LICENSEE: Niagara Mohawk Power Corporation

FACILITY: Nine Mile Point Nuclear Station Unit No. 1

SUBJECT: SUMMARY OF TELEPHONE CONVERSATION OF APRIL 3, 1997, REGARDING  
RECIRCULATION PIPING WELD

## RECIRCULATION SYSTEM WELD INDICATION RESPONSES TO NRC QUESTIONS

NMP1  
Loop 12  
Reactor Recirculation

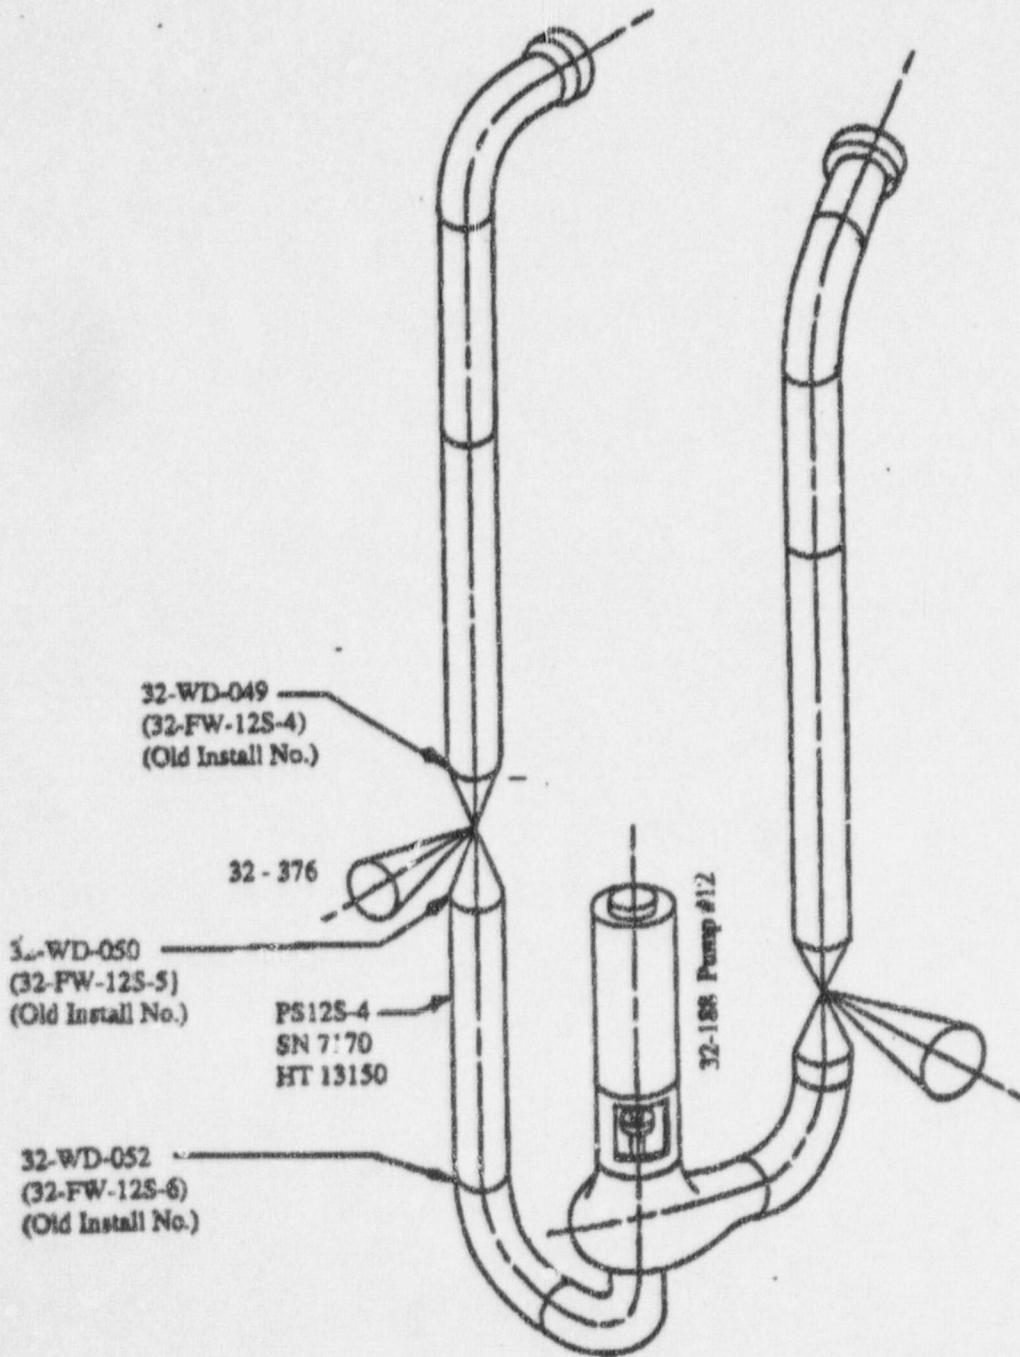
**ADDITIONAL INFORMATION****Location:**

See simplified sketch. Upstream of weld 32-WD-050 is the loop 12 suction blocking valve 32-376 and downstream is a 11'-5.5" length of 28" pipe.

NDE Report: 1-6.03-97-0219  
 Work Document: NMP-151-002 R.O  
 Page 3 of 4  
 Exam Item: 32-WD-050  
 Procedure/Rev.: 6.03 REV-11

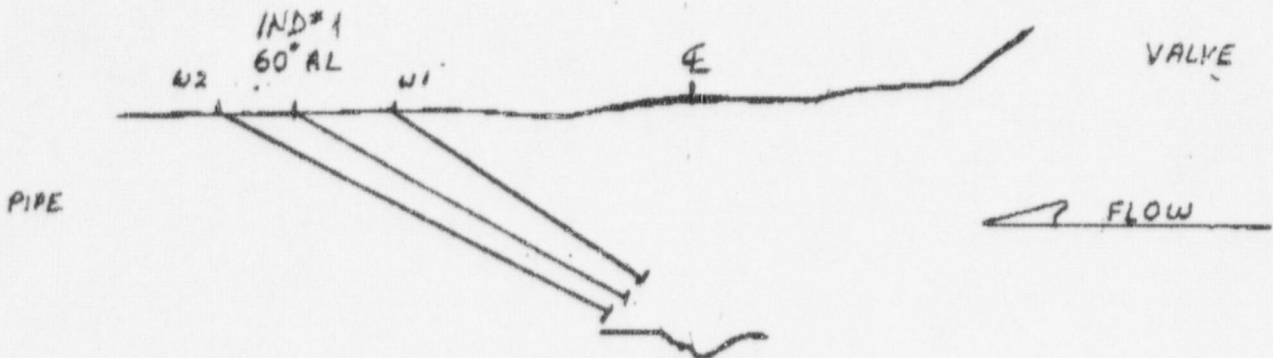
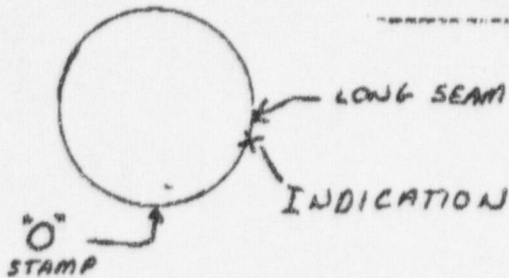
NOTE: PEAK AMPLITUDE ATTAINED BY SKEWING TRANSDUCER  
 10"-15" BACK TOWARD "0"

NDE Report: INFORMATION SKETCH: FLAW LOCATION  
 Work Document: RELATIVE TO ROOT  
 Page 1 of 1 REPAIR AREA  
 Exam Item: WELD # 32-WD-050  
 Procedure/Rev: N/A

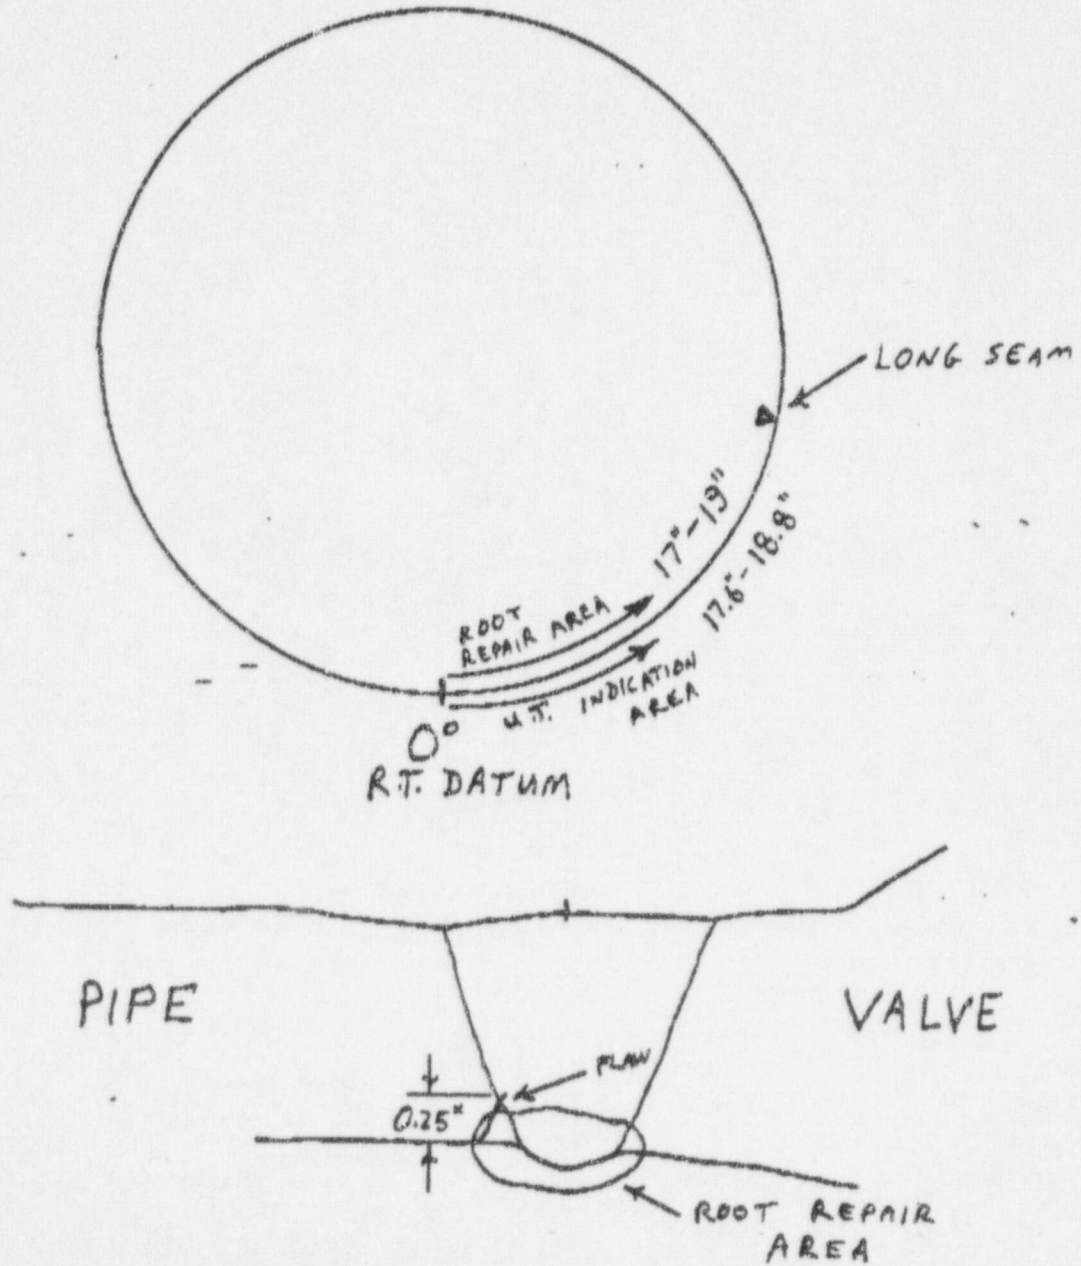
See response to question 4. NMPC has verified that area of incomplete fusion identified and repaired in 1983 (installation) is in the same location as indication found in RFO14. UT performed in 1986 following IHSI identified "no relevant indications found."

Indication is either a reflector caused by an unsuccessful repair at installation or cracking initiated due to stresses in the localized repair area.
